Project	IEEE 802.16 Broadband Wireless Access Working Group < <a href="http://ieee802.org/16">http://ieee802.org/16</a> >	
Title	Clarification of CQICH allocation request header	
Date Submitted	2005-03-17	
Source(s)	Yongseok Jin, Bin-Chul Ihm, Jin Young Chun LG Electronics. Inc.	Voice: 82-31-450-7187 Fax: 82-31-450-7129 <a href="mailto:jayjay@lge.com">jayjay@lge.com</a>
	Jung Je Son Samsung Electronics	<a href="mailto:jungje.son@samsung.com">jungje.son@samsung.com</a>
Re:	This is a contribution to IEEE 802.16e.	
Abstract	In the current document of 802.16e, i.e., 16e/D6, the type field code allocation is problematic, e.g., duplicated allocations. This contribution proposes to add tables to list the type fields encodings and also to clean up the type code allocation problems in 16e/D6.	
Purpose	To correct the errors of the type code allocations and also to improve the type code allocations.	
Notice	This document has been prepared to assist IEEE 802.16. It is offered as a basis for discussion and is not binding on the contributing individual(s) or organization(s). The material in this document is subject to change in form and content after further study. The contributor(s) reserve(s)

Figure 20d—CQICH Allocation Bandwidth request

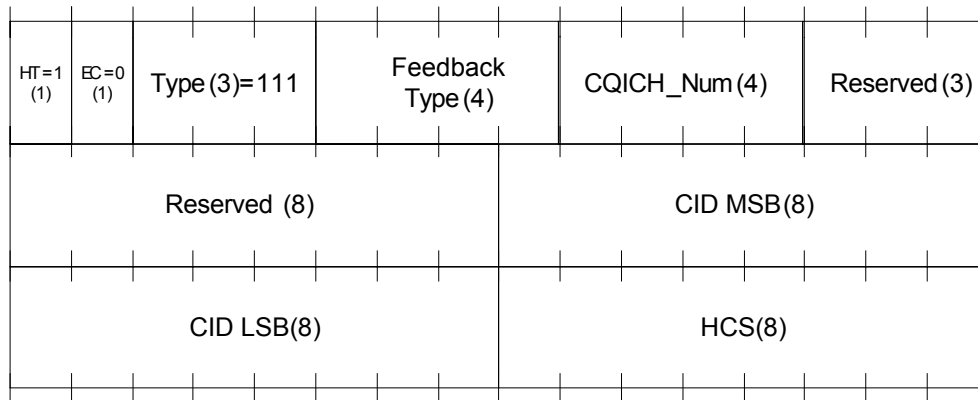
*[Insert new sub clause 6.3.2.1.2.3:]*

### 6.3.2.1.2.3 CQICH Allocation Request Header

The CQICH Allocation request PDU shall consist of CQICH Allocation request header alone and shall not contain a payload. The CQICH Allocation request header is illustrated in Figure 20d
